JP-8 SERVICE NOTES

Second Edition
December.1982

This Notes makes First Edition obsolete and consists of two parts:

Part 2 Mainly applicable to JP-8 units with Serial Numbers

INTERFACE BOARD OPH122A

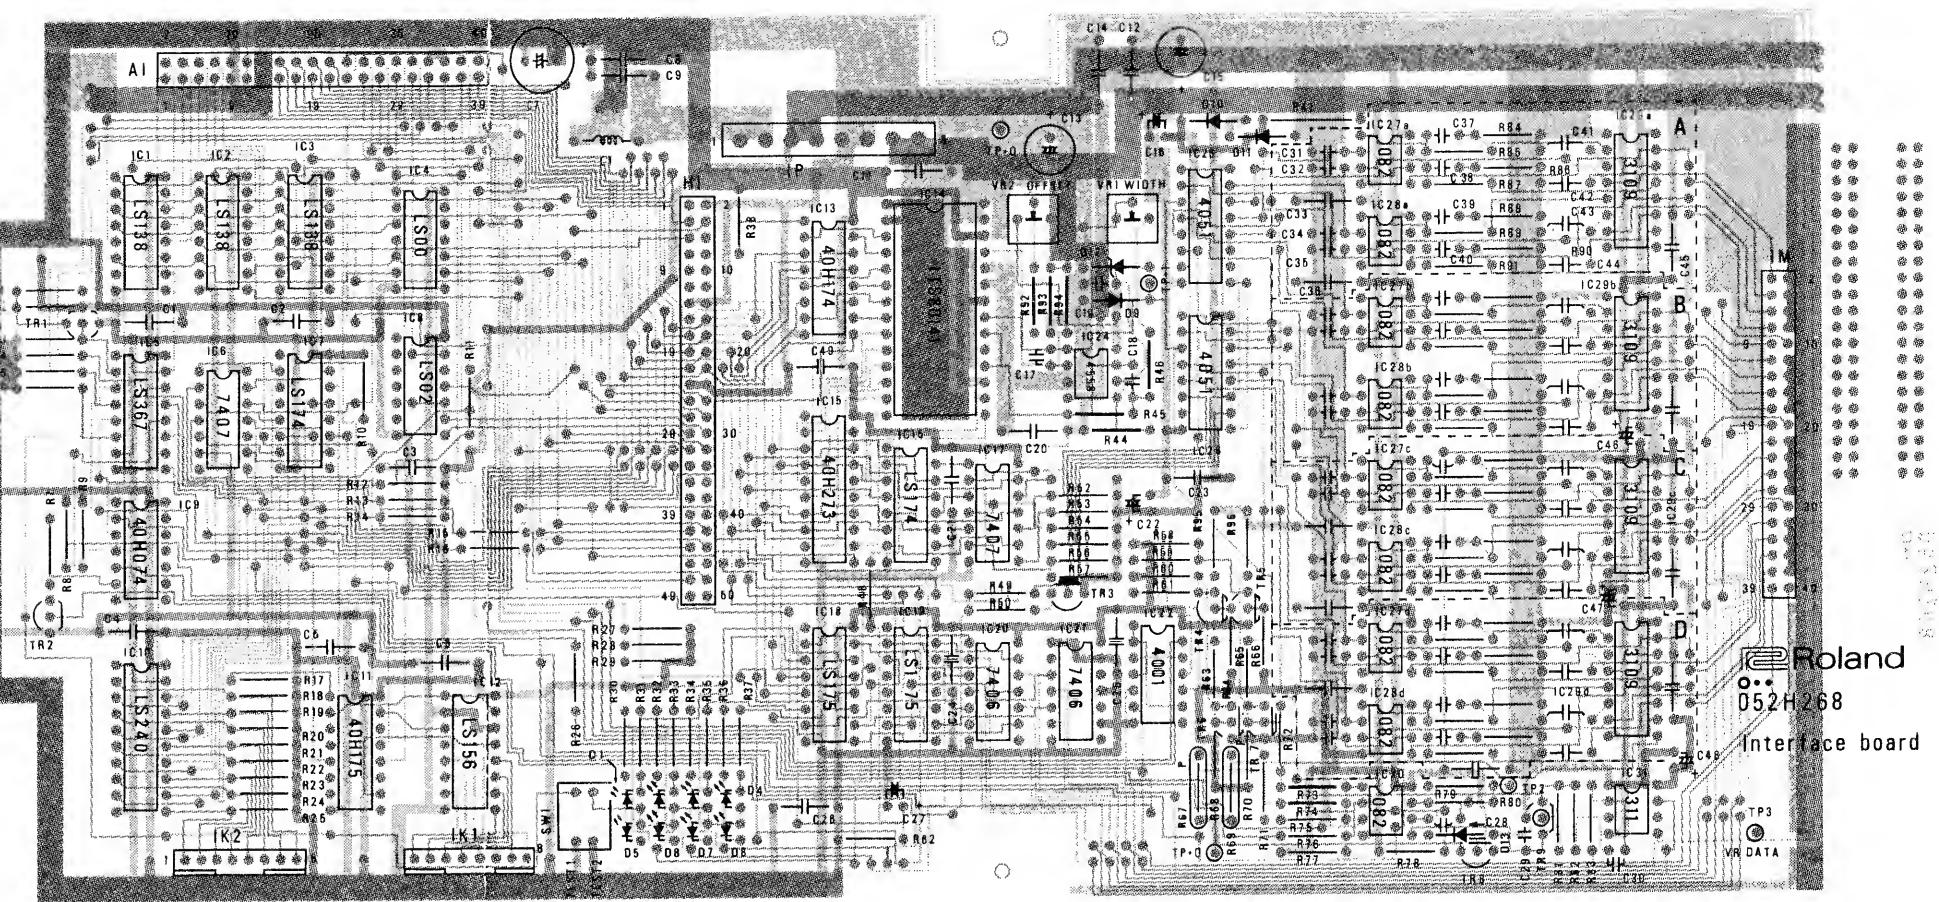
The D/A Converter IC14 is changed from 12-bit Am6012 to 14-bit ITS80141 with this PCB version. Along with the change the following parts are also changed.

Replace existing PROMs with these PROMs.

Adjust DAC circuit, referring to "4. DAC" on p.25 of this book.

MODULE CONTROLLER BOARD SN 202100 and UP
 OPH123A (149H123A) (pcb 052H269)

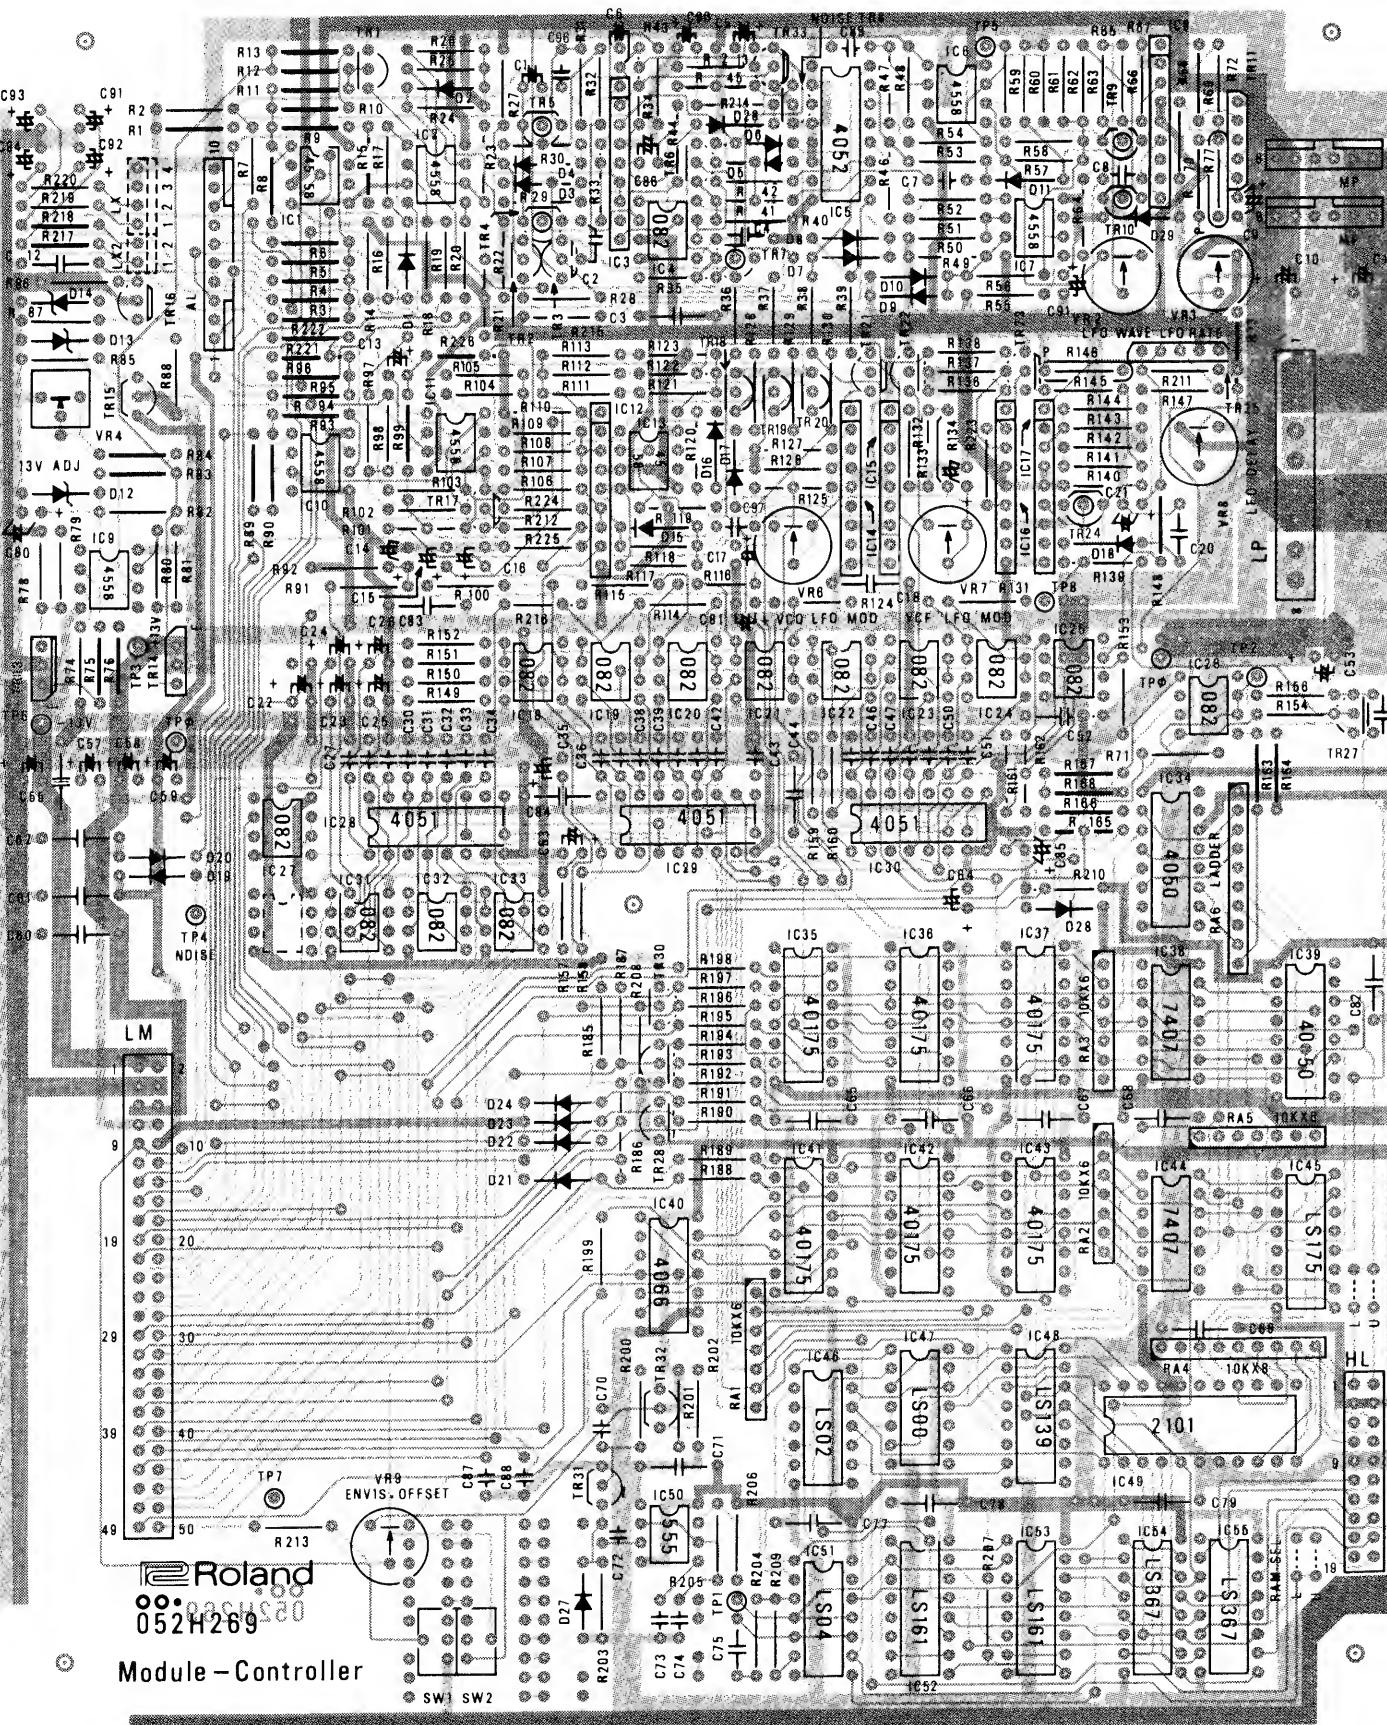
7. Add D29 and C95 to +B pin of IC7 (S, 36)
 to stabilize the supply voltage8. Add RC filters on EXT CV lines (L, 43; S, 41;
 E, 35; D, 33)

Apply a ground to pin 5 of IC2 through R21, previously -15V. Change resistors values in this section

Add C97 across pins 1 and 2 of IC13

11. Add TP-8 (Q, 36-37)

IC49 OF MOD CON BOARD (MODIFICATION ON CPU BOARD)

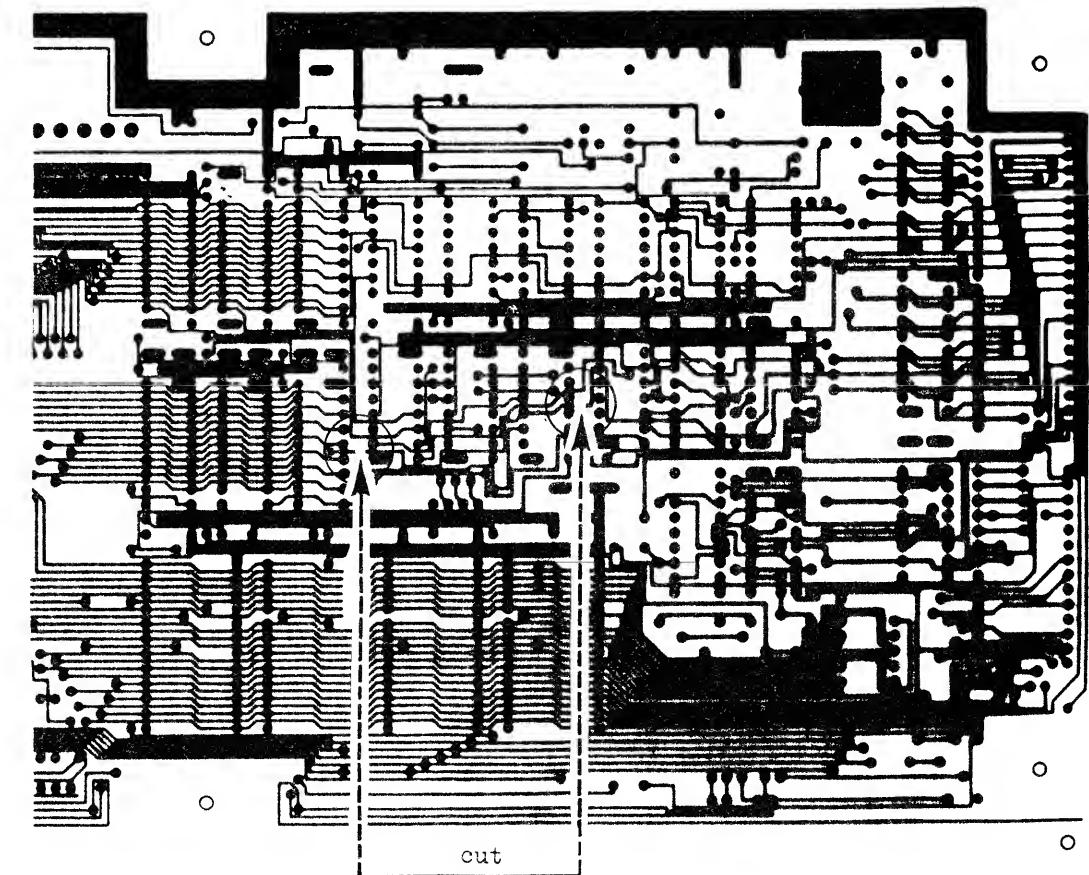
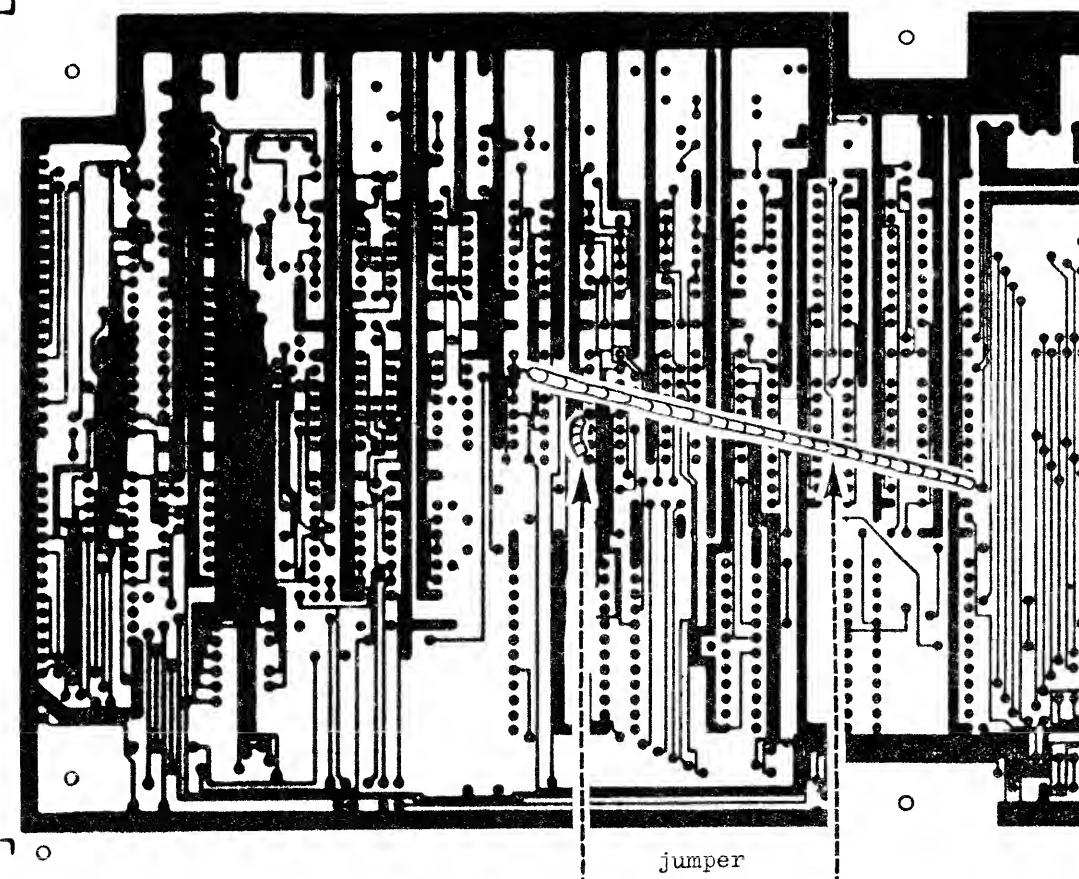
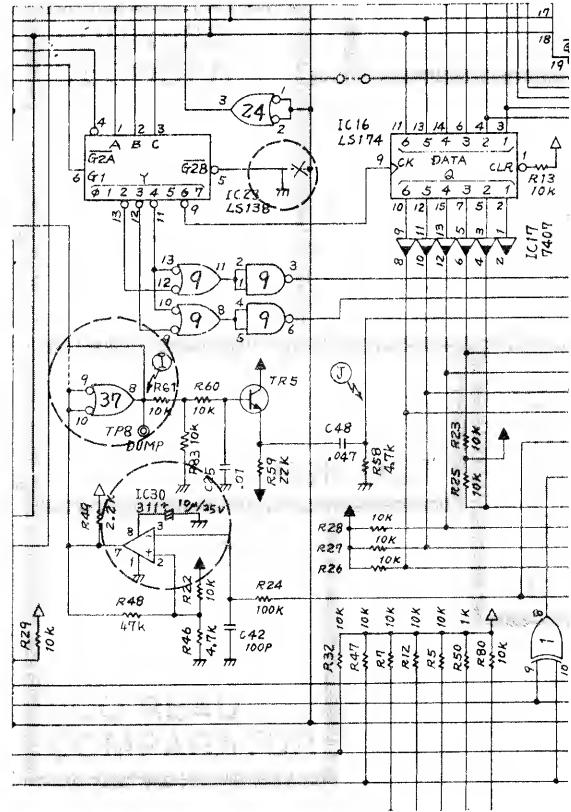
Check IC49 on the both PCBs (being replaced and replacement) for name. If 2101 is on the existing PCB and 5101 on the replacement, take the modification illustrated below.

Below, two minor modifications (independent of RAM change) are also indicated:

Reconnection of IC37 and addition of 10UF at IC30
pin 8

Adjust VR1 (NOISE LEVEL) of unchanged MOD CON board to match the noise level of new board which omits the adjustment. Reconnect R21 of unchanged MOD CON, referring to drawing to the right. This will eliminate possible loudness differences between U and L voices.

This modification has no adverse effect on 2101.

DCB CONNECTOR ASS'Y**MODULE CONTROLLER BOARD**

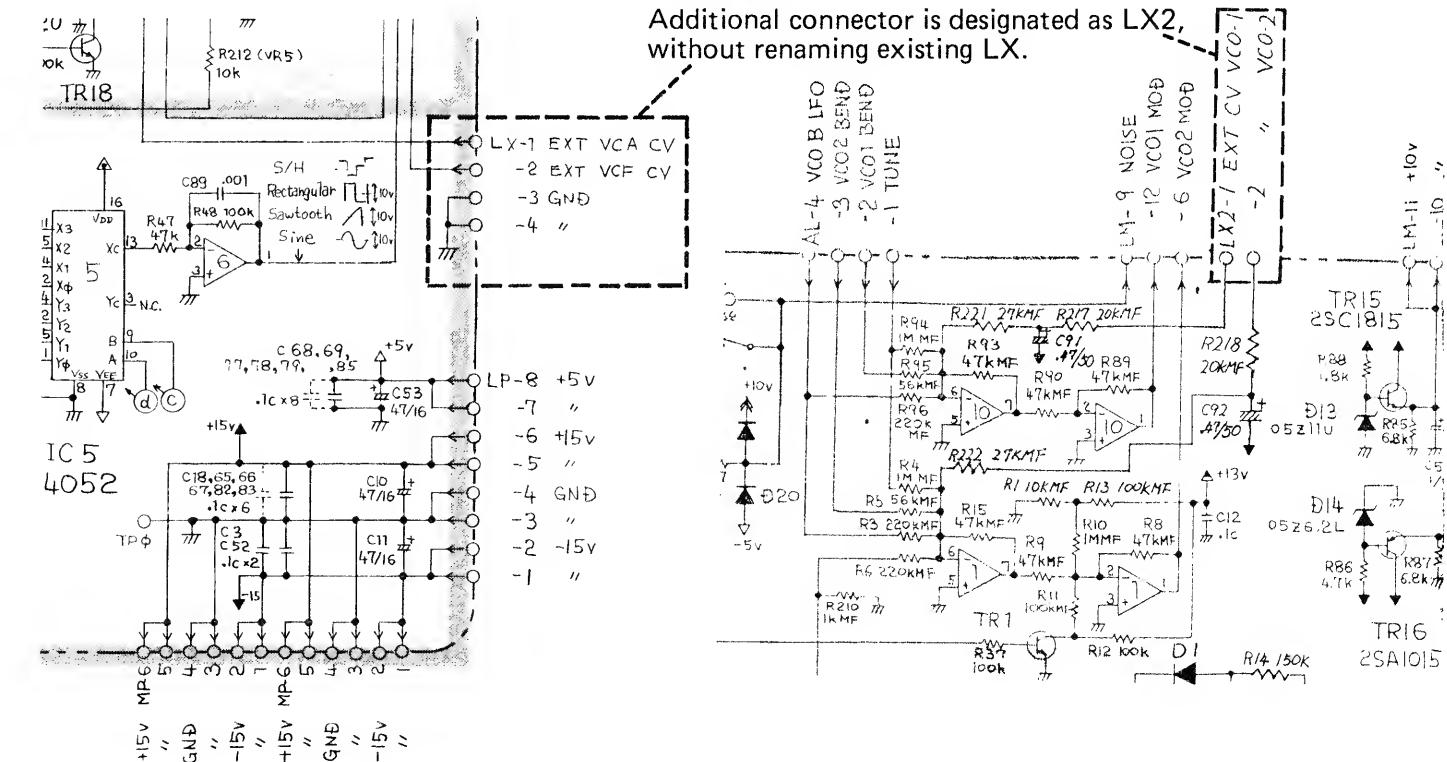
Additional connector is designated as LX2, without renaming existing LX.

PATTERN-CUTS ON MOD CON

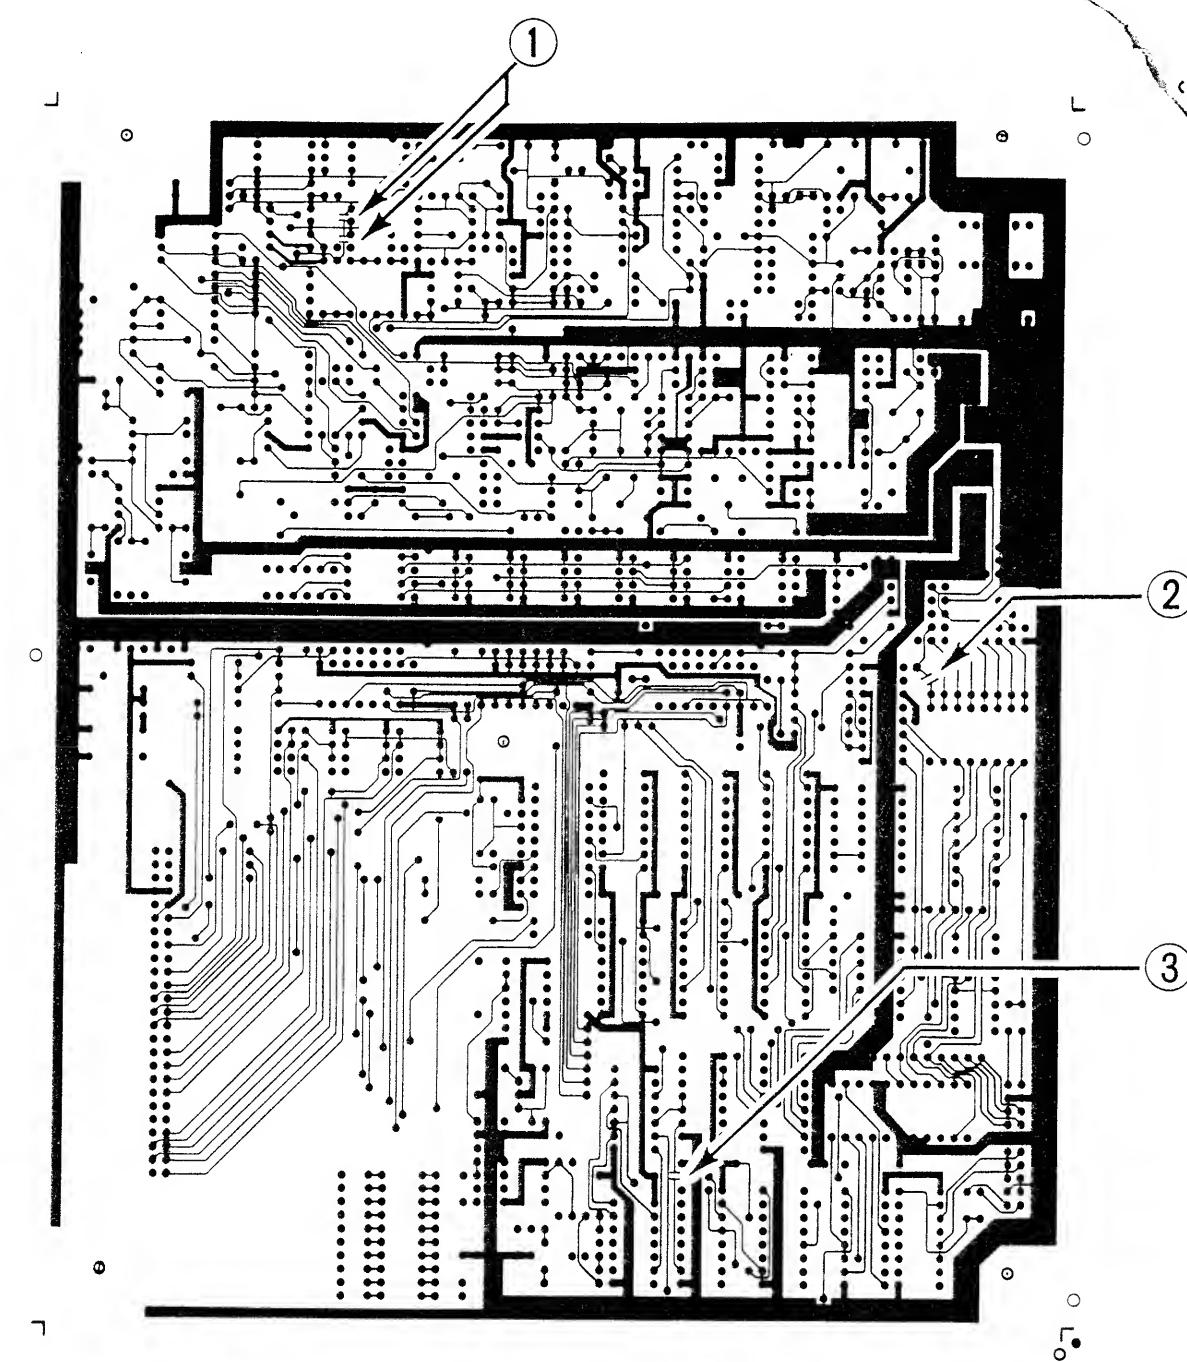
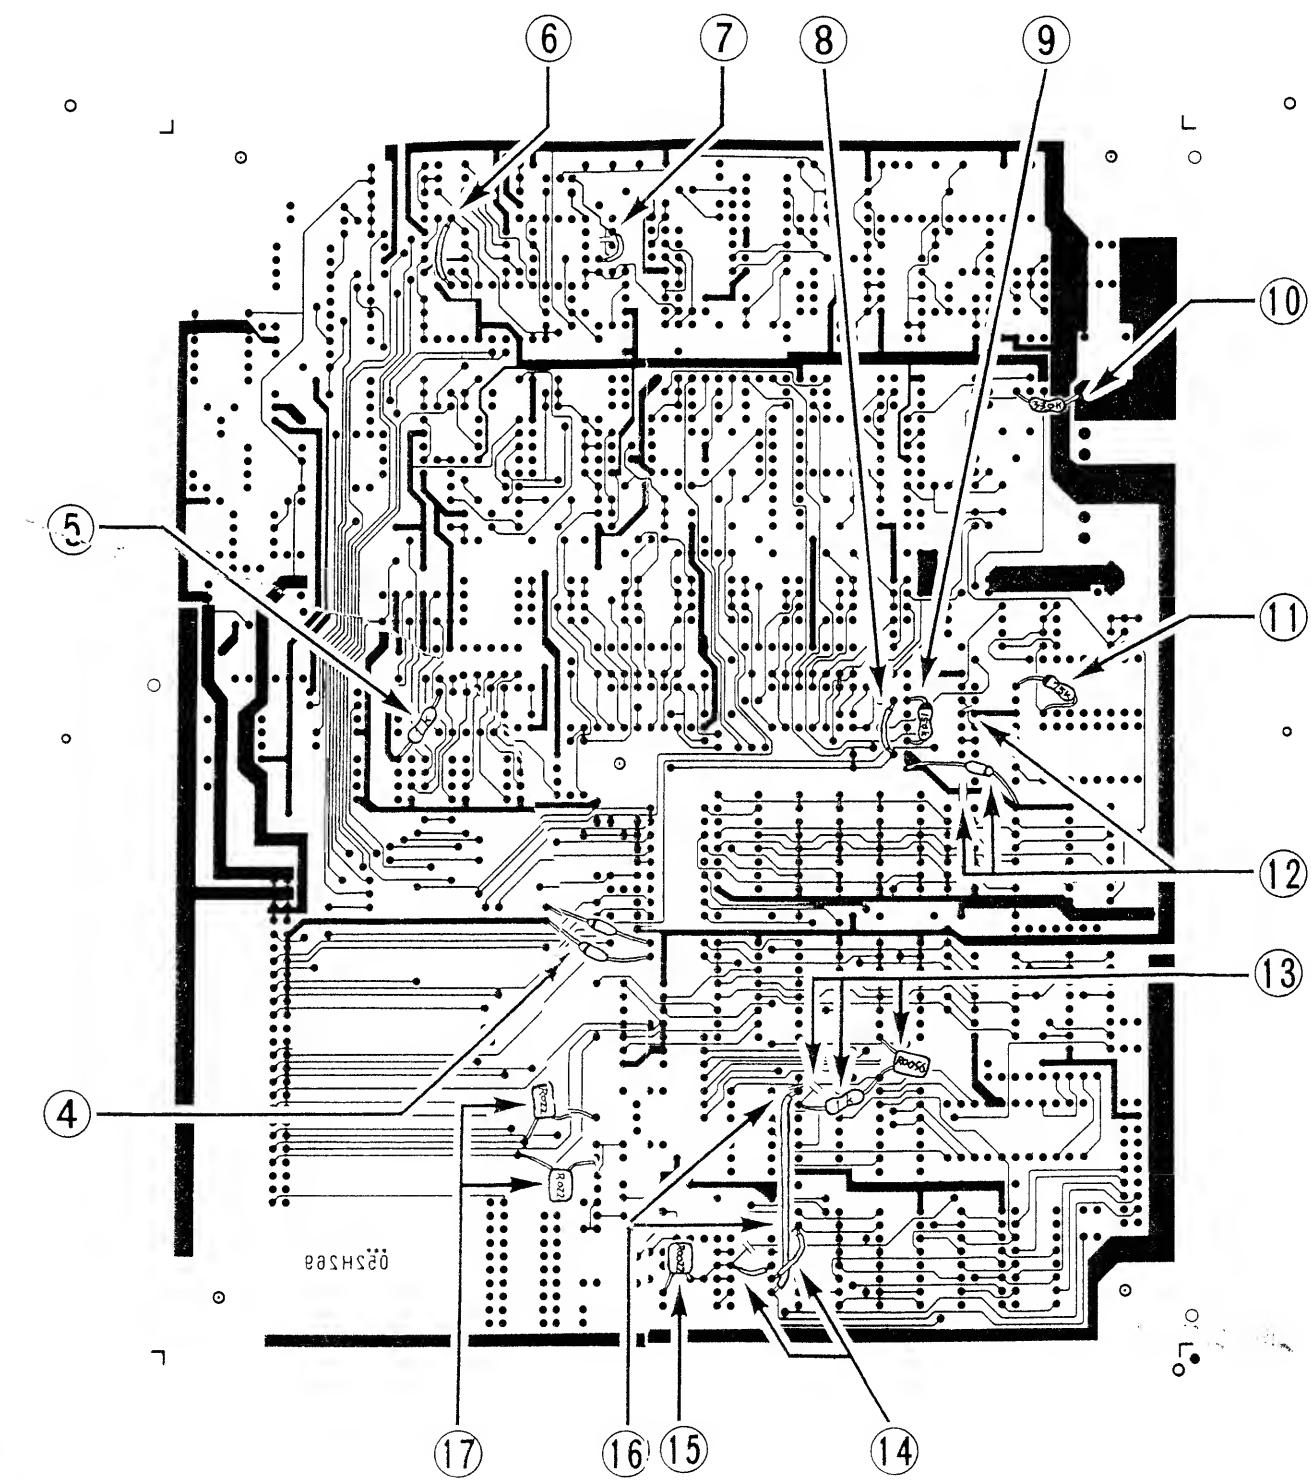
PATTERN-CUTS & SURFACE-MOUNTINGS
ON MOD CON
